SUBJECT: Duke Energy Corporation

Oconee Nuclear Station Units 1, 2, & 3
Docket Nos. 50-269, 50-270, 50-287

Nuclear Quality Assurance Program
Amendment 29

Pursuant to 10CFR50.54 (a) (3) and 10CFR50.71 (e), attached is Amendment 29 to the Duke Energy Corporation Topical Report, Duke-1-A, *Quality Assurance Program* (hereafter referred to as Topical Report). Amendment 29 includes organizational changes, administrative and editorial changes.

Figure 17-2 Duke Energy Corporation Corporate Organization

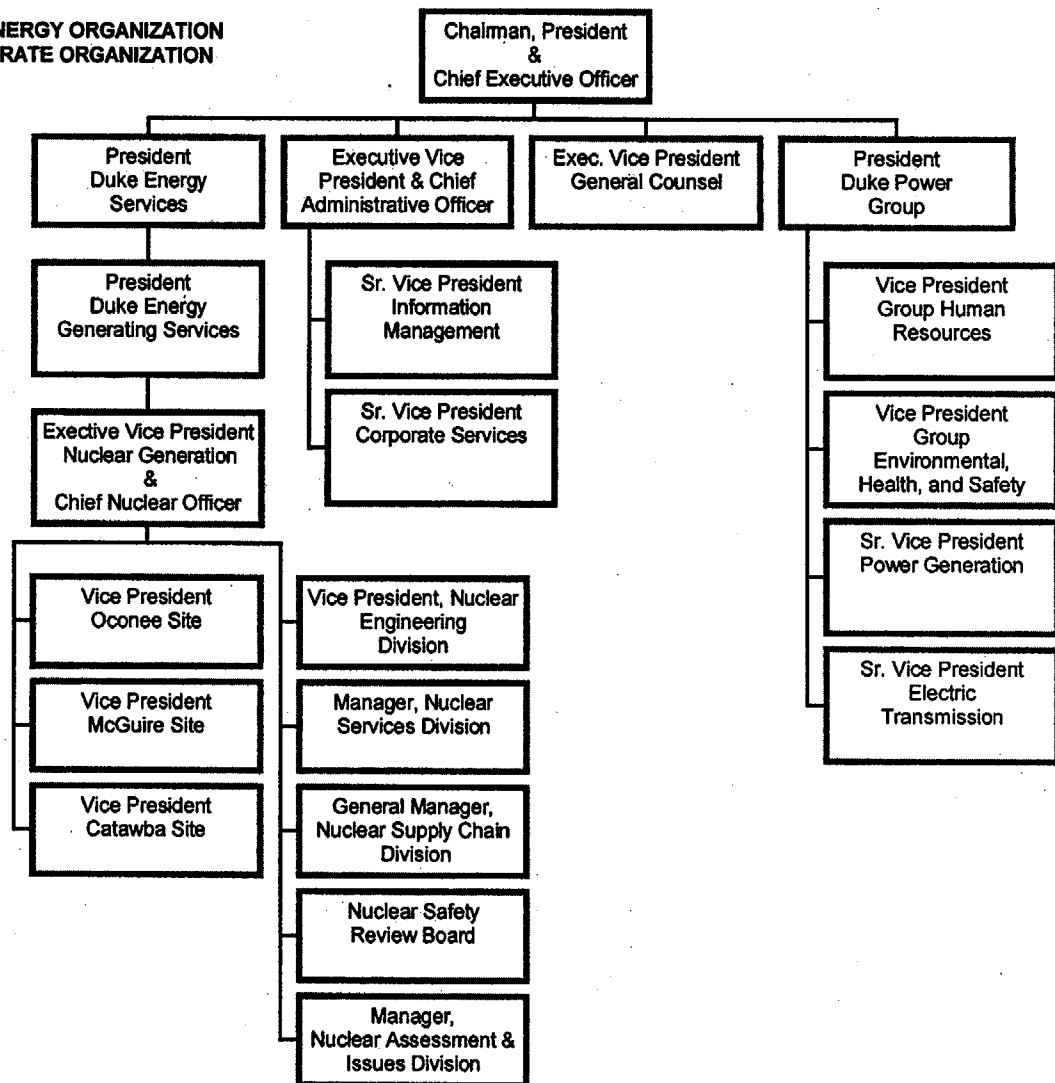
8. **Figure 17-2 Corporate Organization**, revised the organization to reflect corporate organizational changes.
9. **Figure 17-3 Off-Site Organization**, revised chart to reflect corporate organizational changes.

Figure 17-4 Nuclear Site Organization

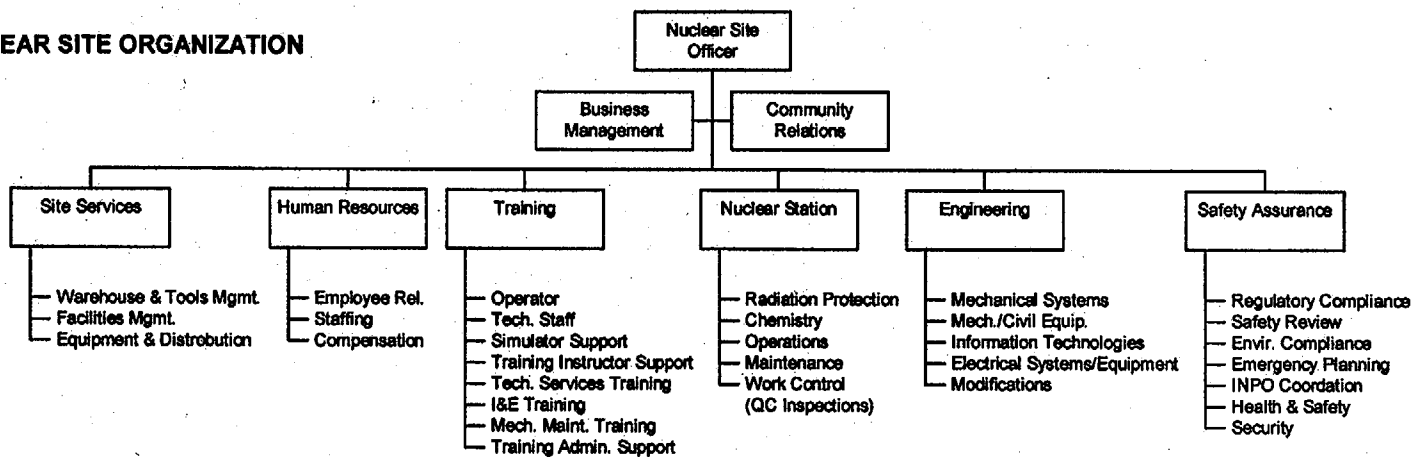
10. **Figure 17-4 Nuclear Site Organization**, revised chart to reflect Nuclear Site organizational changes that moved Security's reporting alignment from Human Resources to Safety Assurance.
